Product:Washing	Noise in FHP-motor Part No. 8063734	Group:21	
Date: 2002-08-20		Number: 177	
Reference:N-Å Carlsson		ÄO:	Page: 1(1)

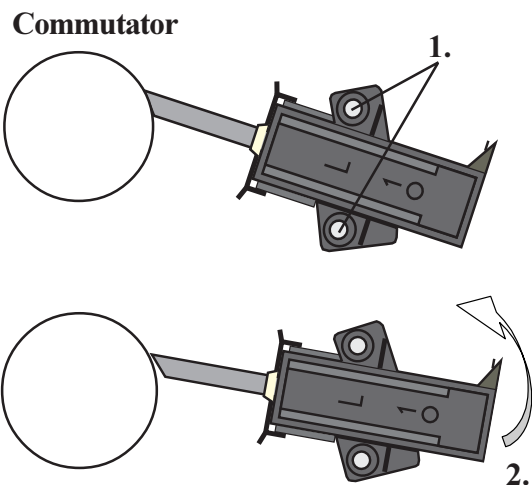
After only a short period of use, noise might be emitted by the motor, Part No. 8063734 .

The noise may be perceived as a high-frequency squeaking or a ticking noise, and in most cases it will be heard in one direction of rotation only.

The noise occurs when the carbon brush (now made of a harder material) makes contact with the commutator at the wrong angle

1. Slacken the 2 retaining screws for each brush holder; see Fig. 1.
2. Rotate the brush holder slightly (ca. 1 mm) so that its tip is more in alignment with the commutator. The brush will now adopt a different angle to the commutator and will have a different contact surface; see Fig. 2.
